PLANNING COMMISSION MEETING AGENDA
TUESDAY FEBRUARY 21, 2023

- c. February 9, 2022, City Council Meeting Minutes (For Information Only)
4. **Continued from January 17, 2023 Meeting.** William Stoddard (Applicant) and John Zeglin (Owner) requests that the City consider the following actions for the property located at 9285 US Hwy 12, Independence, MN (PID No. 18-118-24-21-0001):

- b. Rezoning of a portion of the property from AG-Agriculture to UC-Urban Commercial.
 - c. Conditional Use Permit to allow a planned unit commercial development on the subject property. The proposed development would include office warehouse and private garage condominium buildings.

4 **MOTOR CONDOS - SIDE ELEVATION**
A3.1 3/32" = 1'-0"

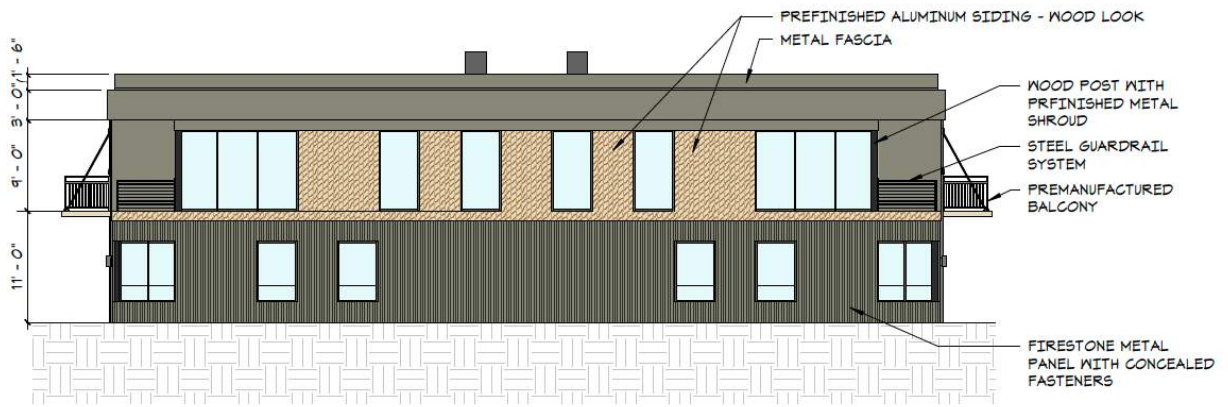
The applicant is proposing to construct the buildings using primarily metal paneling (see illustrative elevation below). The City will request examples of the proposed materials. The proposed architecture is consistent throughout the development, utilizes significant amounts of glass and glazed surfaces and appears to meet the design intent of the ordinance. Staff will be seeking additional discussion and direction from Planning Commission relating to the proposed building materials and architecture.
